## Replies to FIFC questions on E10 experiment

Figure 1: S/N ratio as a function of energy resolution in the case of the  ${}^6_{\Lambda}\text{H}$  production. For more details see the text.

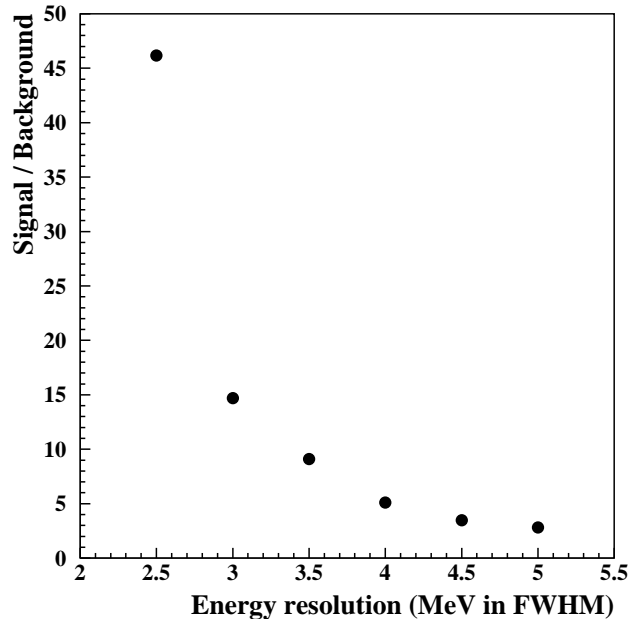
Q4 : Can you show us the significance of signals as a function of energy resolution in order to verify the 2.5MeV (FWHM) requirement ?

A4 : Figure 1 is a result of the calculation of the S/N ratio in the case of the  ${}^6_{\Lambda}\text{H}$  production. In the calculation, the energy threshold of particle decay channels in  ${}^6_{\Lambda}\text{H}$  is assumed to be 3 MeV. The ratio of yields between the signal (hypernucleus production) and the background (quasi-free  $\Lambda$  production from  $0 < -BE < 20\text{MeV}$ ) is assumed to be 1:10. These parameters are same as that used in the discussion described in the document for FIFC (see Fig.2 in the document). The energy window for signal selection are set to  $\pm 2\sigma$  ( $\sigma$  is the energy resolution in rms).

The result shows the signal is quite significant in the case of the 2.5 MeV resolution. The S/N ratio drops quite rapidly with the increase of the energy resolution.

Figure 2: Simulated hit distributions at DC1 and DC2. Black and red colored histograms corresponds to hypernuclear events and beam hits, respectively. See text for more details.

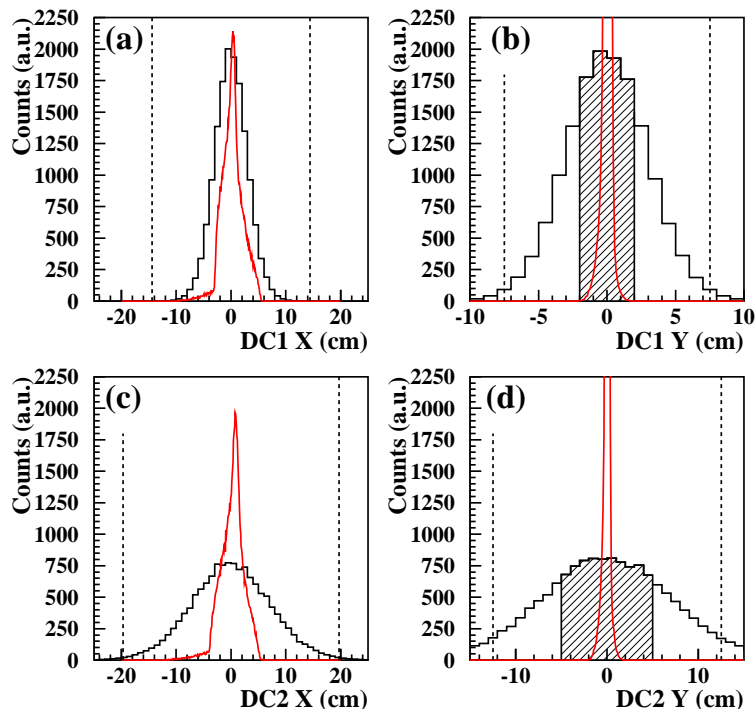
Q7 : Can you show us  $K^+$  distribution in DC1, DC2 together with the beam ?

A7 : Figure 2 shows simulated hit distributions at DC1 and DC2. The distribution projected to the x (a) and y (b) axes at DC1, and the x (c) and y (d) distributions at DC2. The black colored histograms correspond to events with the production of hypernuclei, and red colored histograms correspond to beam hit distributions.

For the simulation, the angular dependence of the differential cross section of the production cross section of hypernuclei is included in the black histograms, but the SKS acceptance is not included. The SKS acceptance changes the  $x$  distributions, (a) and (c), a little. For the  $y$  distributions, (b) and (d), the hatched areas roughly show the SKS acceptance.

The vertical dashed lines indicate the edge of DC1 and DC2.

Figure 3: Hit profile change from BC3 to the final focus point (FF) in the x (horizontal) direction.

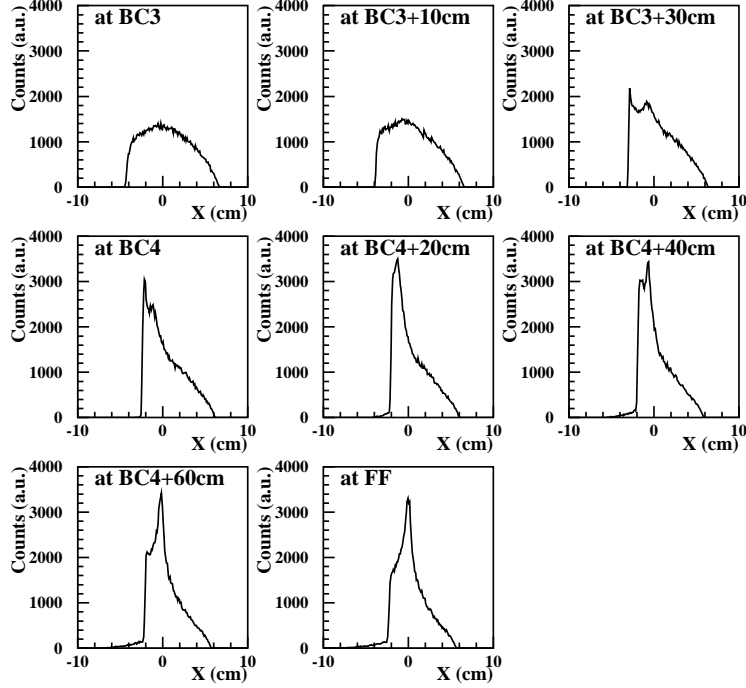
Q12 : Can you explain the beam distribution in BC4, p.11, especially the sharp edge in left ?

We believe these design of the beam optics creates the somewhat “singular” beam profile at BC4.

Figure 3 shows the hit profile change from BC3 to the final focus point (FF) in the x (horizontal) direction. The beam focusing becomes significant around BC4 position. The peak structure at the left end at the BC4 position seems to move toward center ( $x=0$ ) from BC4 to FF.
